Access Compliance Report

Public Rights-of-Way

(Curb Ramps)

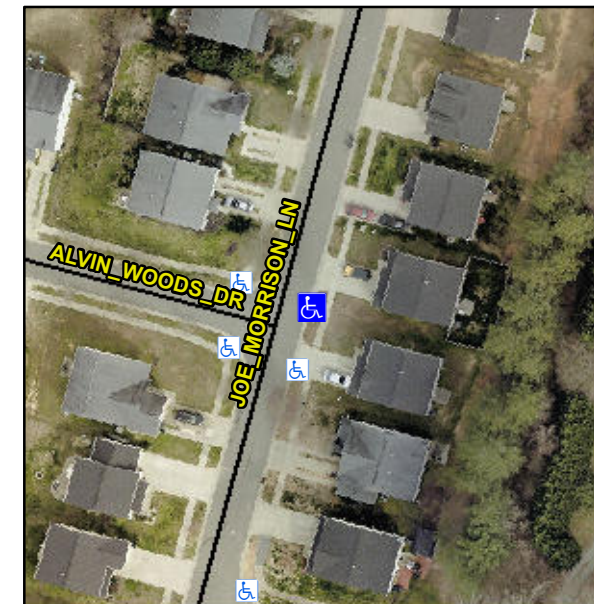
Intersection ID: 48392	Main Street: ALVIN_WOODS_DR	Cross Street: JOE_MORRISON_LN	Location:	E
ADA ID: 81D61083A1D1	Ramp Type: Perp	Initial Pass/Fail: Fail	Overall Compliance: No	Severity Score: 8.75
Codes/Mitigation Info/Possible Solution		Field Measurements/Component Compliance

R304.5.1

Compliance	Description	Data	Compliance	Description	Data
N/A	Ramp Length (in)	72.0	Yes	Ramp Slope (%)	5.8
No	Ramp Width (in)	47.5	Yes	Ramp XSlope (%)	1.3
N/A	Flare Type LT	N/A	N/A	Flare Type RT	N/A
N/A	Flare Slope LT (%)	N/A	N/A	Flare Slope RT (%)	N/A
N/A	Flare Traversable LT?	N/A	N/A	Flare Traversable RT?	N/A
N/A	Landing Length (in)	N/A	N/A	DWS Provided?	N/A
N/A	Landing Width (in)	N/A	N/A	DWS Contrast?	N/A
N/A	Landing Slope (%)	N/A	N/A	DWS Length (in)	N/A
N/A	Landing X Slope (%)	N/A	N/A	DWS Full Width?	N/A
N/A	Landing Curb? (Y/N)	N/A	N/A	DWS Offset (in)	N/A
N/A	Shared Landing?	N/A			
N/A	Gutter Ponding?	N/A	N/A	Gutter Slope (%)	N/A
N/A	Gutter Lip Ht (in)	N/A	N/A	Gutter X Slope (%)	N/A
N/A	Painted X Walk1?	No	N/A	Painted X Walk2?	N/A
	X Walk 1 Direction	To NW		X Walk 2 Direction	N/A
N/A	X Walk 1 Width (in)	N/A	N/A	X Walk 2 Width (in)	N/A
	X Walk 1 Slope (%)	2.0		X Walk 2 Slope (%)	N/A
	X Walk 1 X Slope (%)	1.7		X Walk 2 X Slope (%)	N/A

Remove & Replace Entire Ramp.
